PART NUMBER 11-1064A

DOC,UPGRADE,CA04733,
PED DRBRIS FUSE,MTA

| REV | DOC | SHEET | OF |
|---|---|---|---|
| 719 - 00342A - A | AD | 1 | 1 |

## UPGRADE INSTRUCTION

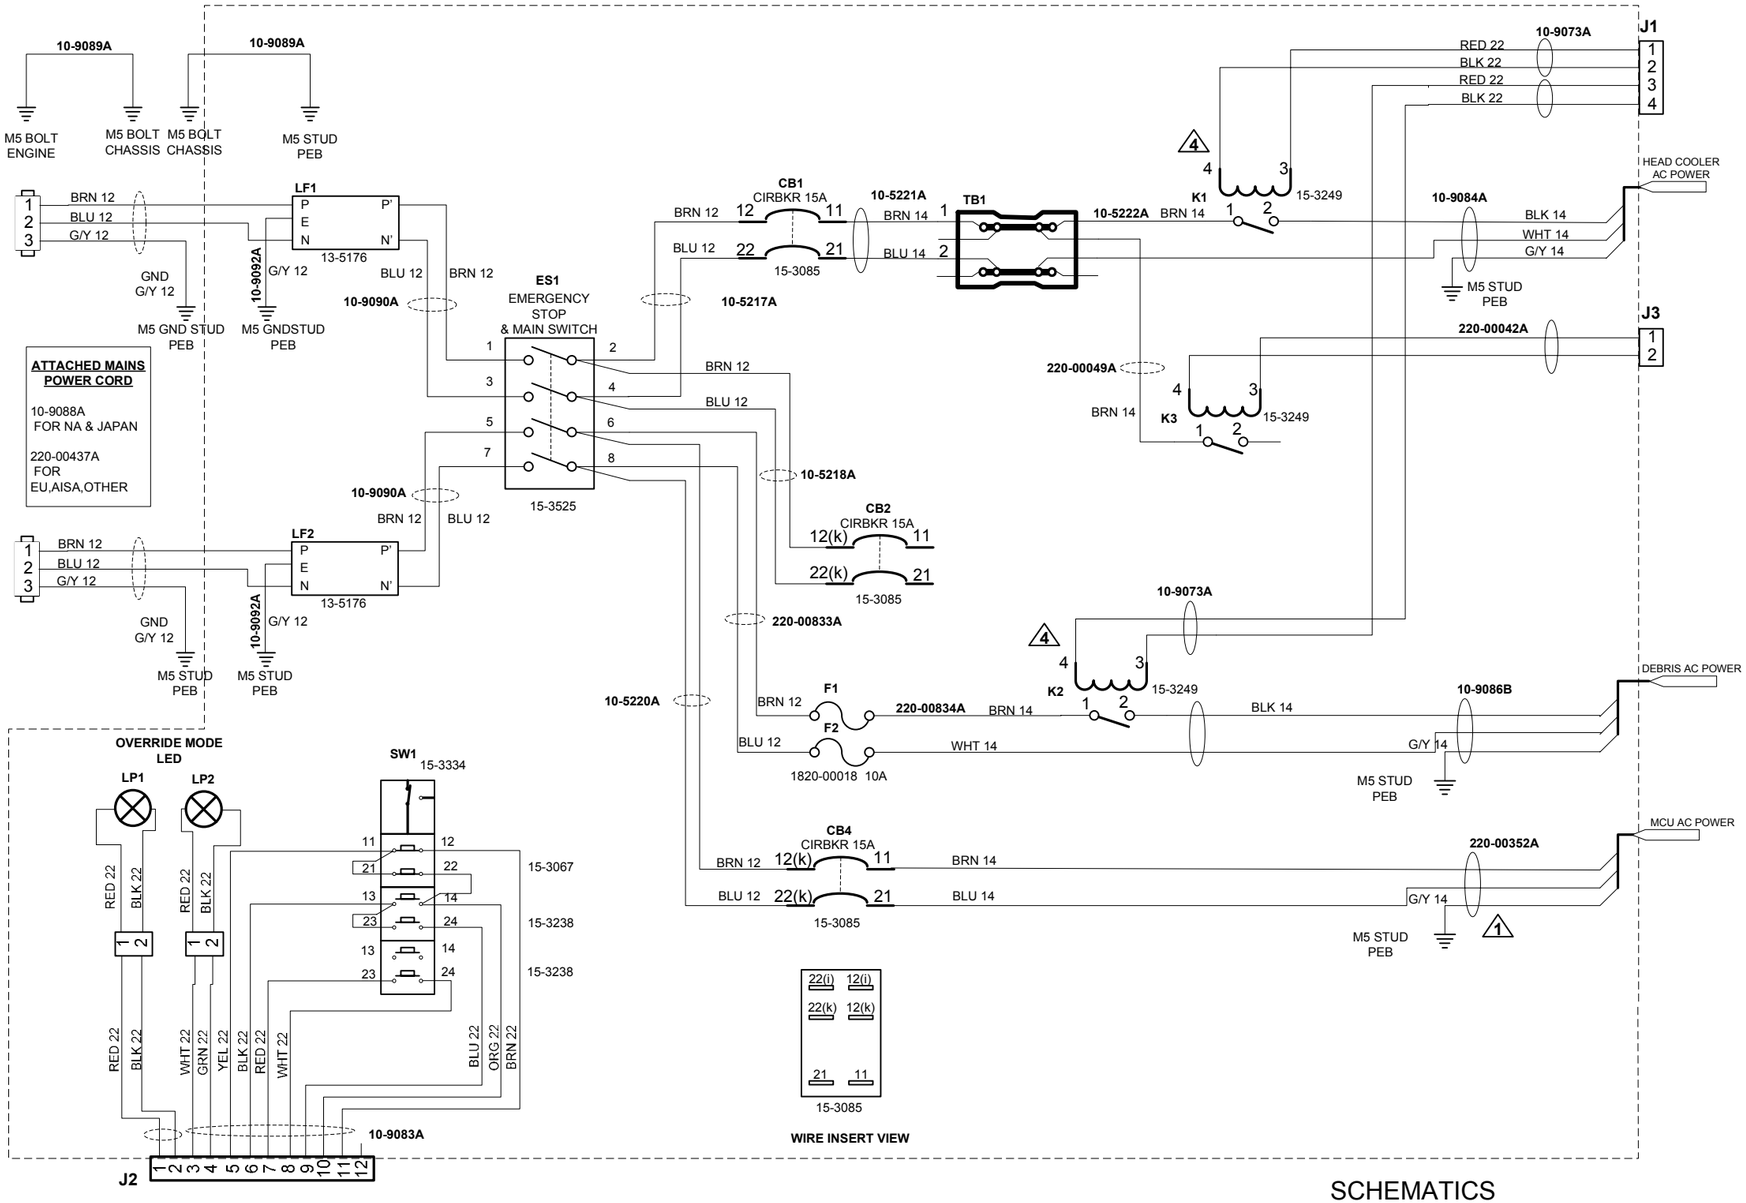
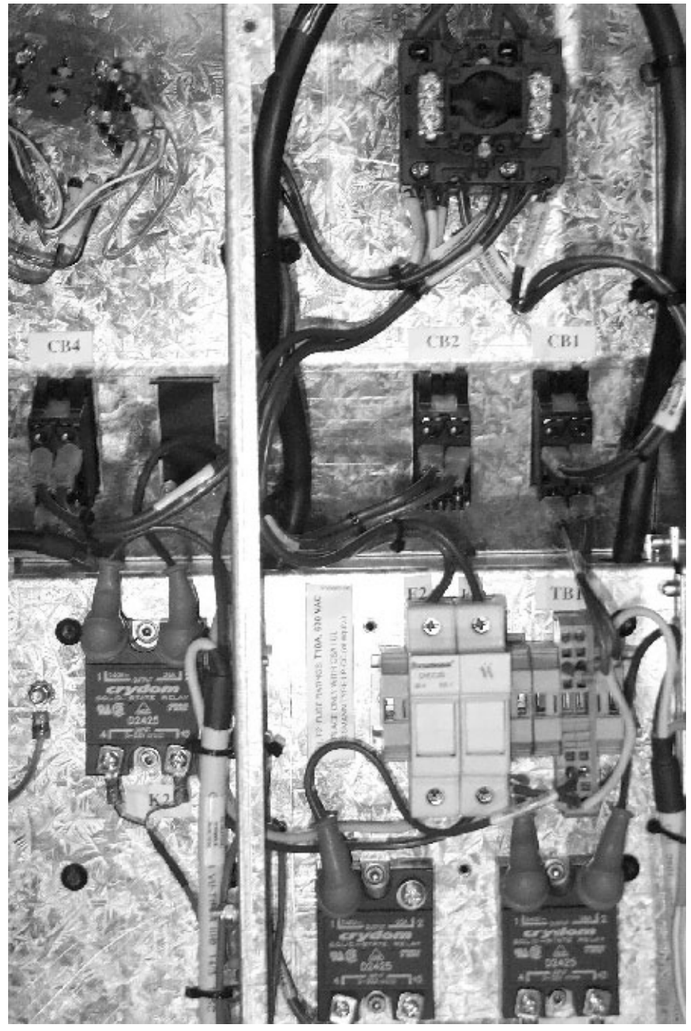
1. PULL OUT WIRE CONNECTION OF 10-5219A FROM CB3
2. CUT THE PUSH_ON TERMINALS FROM 10-5219A, AND STRIP OFF THE WIRE JACKET FOR 10mm AT THE WIRE ENDS. RE-LABEL THIS WIRES TO BE 220-00833A WITH STICKER (74-3003). CONNECT BROWN WIRE OF THE NEW 220-00833A TO F1 (UPPER TERMINAL); AND CONNECT THE BLUE WIRE TO F2.
3. PUSH THE FUSE HOLDER (182-00015) ON THE DIN RAIL, HOLD THE FUSE HOLDER IN POSITION WITH 2 PIECES OF END CLAMPS (16-3992).
4. INSTALL 220-00834A (BROWN WIRE) FROM F1 (LOWER TERMINAL) TO K2 PIN 1.
5. CUT THE PUSH_ON TERMNAL FROM THE WHITE WIRE OF 10-9086A, AND THEN ROUTE THE WHITE WIRE TO F2, AND SCREW TIGHTLY TO THE F2 TERMINAL. RE-LABEL THIS CABLE AS 10-9086B
6. PUT LABEL 382-00685A BESIDE THE FUSE HOLDER
7. LABEL THE FUSE HOLDER AS F1, F2
8. REMOVE CB3 SWITCH FROM THE PANEL. INSTALL 58-0286A TO COVER THE HOLE
